FEDERAL SPECIFICATION

PUNCHES AND DIES, AND PUNCH AND DIE SETS - METAL CUTTING, HAND;

AND PUNCH, CLIP, SHEET METAL

This amendment, which forms a part of a Federal Specification GGG-P-840a, dated January 18, 1963, was approved by the Commissioner, Federal Supply Service, General Services Administration for use of all Federal agencies.

FIGURE 1. Type I, class 1, circular punch, light duty.

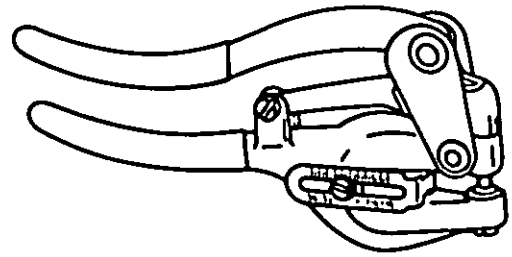
FIGURE 1: Delete and substitute:

FIGURE 2. Type I, class 2, circular punch, heavy duty.

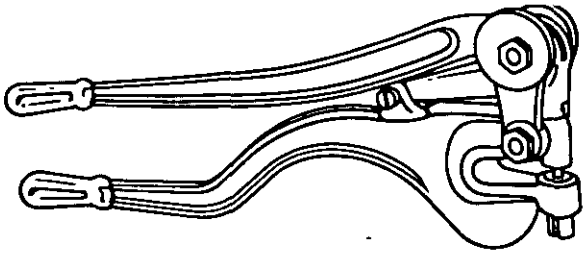
FIGURE 2: Delete and substitute:
